Work Order ID 102005

Item Name: Crosstube Turning Detail

DART AEROSPACE LTD		Work Order:	102005
Description: Crosstube Assembly (412 Low Narrow Aft)		Part Number:	D412-664-245
Inspection Dwg: D412-664-245 Rev: D		Page 1 of 2

DRAWING NO. D412-664-245	TITLE CROSSTUBE ASS'Y (412 LOW-N AFT)	REV. D	DART AEROSPACE LTD ENGINEERING ORDER		D.E.O. NO. D412-664-245-D-1	SHEET NO. SHEET 1 OF 2	SCALE NTS
DRAWN 97	CHECKED SC	MFG. APPR. B	APPROVED MP		DE APPR. H		
DATE 11.05.25	DATE 11.05.31	DATE 11.05.31	DATE 11/05/31		DATE 11.05.31

D412-664-245
ASSEMBLY DETAIL

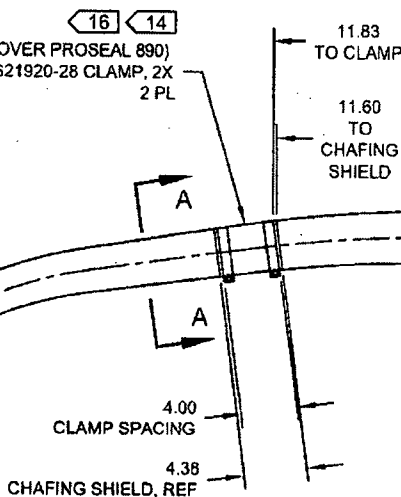
REMOVED ABRASION STRIP IN FAVOR OF A THIN LAYER OF PROSEAL 890. UPDATE INSTALLATION OF CHAFING SHIELDS AND REDUCE TORQUE TO 40-50 IN-LBS. THIS ENGINEERING ORDER SUPERCEDES DEO D412-664-245-D-1

IS:

D3189-1 CHAFING SHIELD (1, INSTALLED OVER PROSEAL 890)
MS21920-28 CLAMP, 2X
2 PL

WAS:

D2856-600-1009 ABRASION STRIP
D3189-1 CHAFING SHIELD (1, INSTALLED OVER ABRASION STRIP)
MS21920-28 CLAMP, 2X
2 PL

SECTION A-A
CHAFING SHIELD DETAIL
VIEW ROTATED, NOT TO SCALE

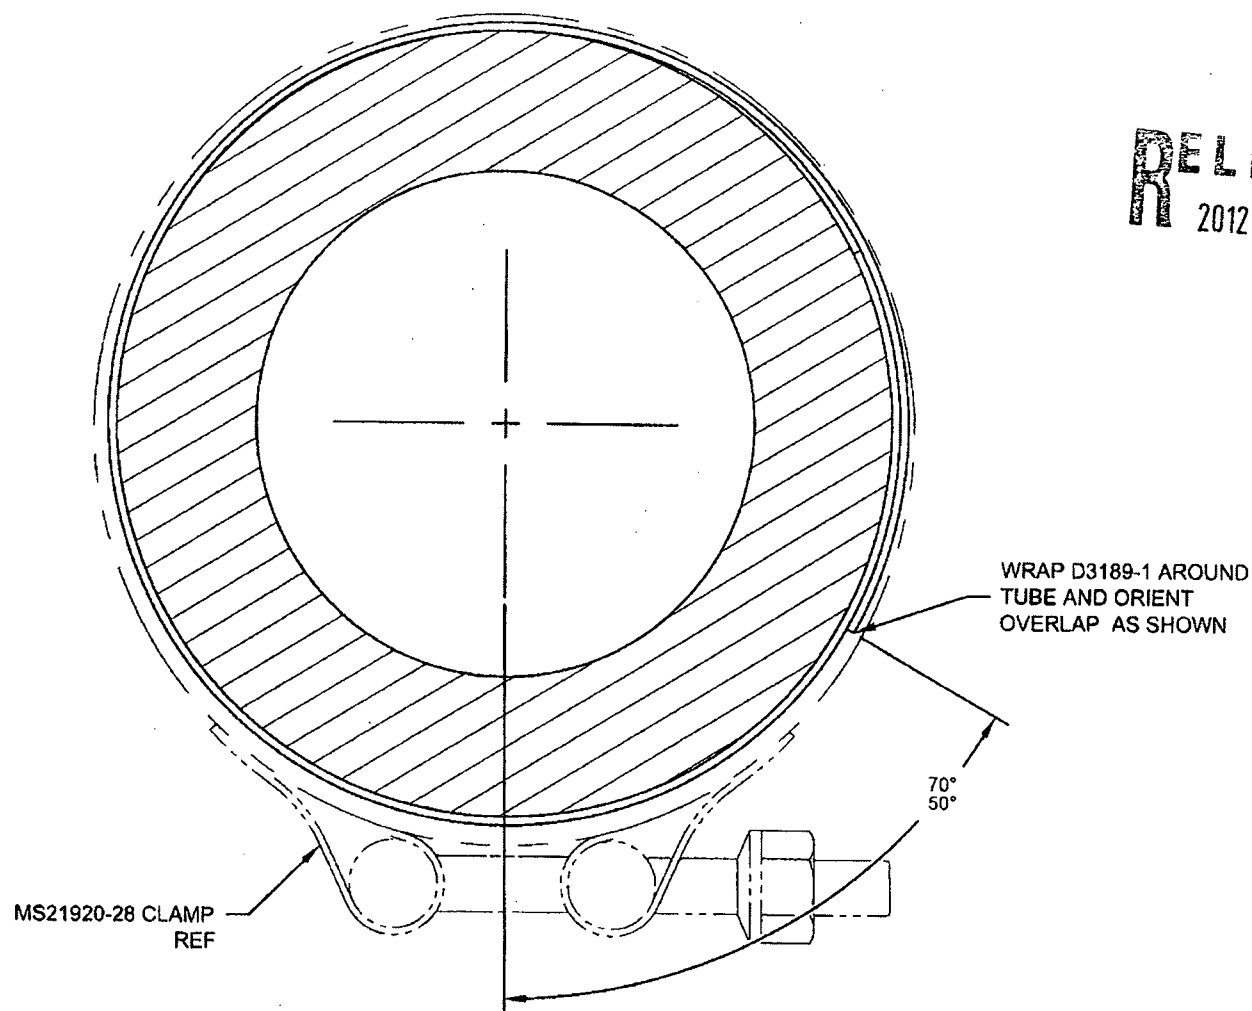
- 14) APPLY A THIN COAT OF PROSEAL 890 ON INSIDE CONCAVE SURFACE OF D3189-1 CHAFING SHIELD AND LET CURE PER MANUFACTURER'S INSTRUCTIONS. INSTALL PROSEALED D3189-1 CHAFING SHIELD ONTO CROSSTUBE BY APPLYING A THIN COAT OF PROSEAL 890 ONTO CROSSTUBE. BE SURE TO ELIMINATE ANY AIR GAPS.
- 16) TORQUE CLAMPS ON D2896-1 SUPPORT 80 TO 100 IN-LB. **TORQUE CLAMPS ON D3189-1 CHAFING SHIELD 40 TO 50 IN-LB.** ENSURE AT LEAST 1.5 THREADS SHOWING IN SAFETY AND THAT NUT HAS NOT BOTTOMED-OUT AFTER TORQUING.
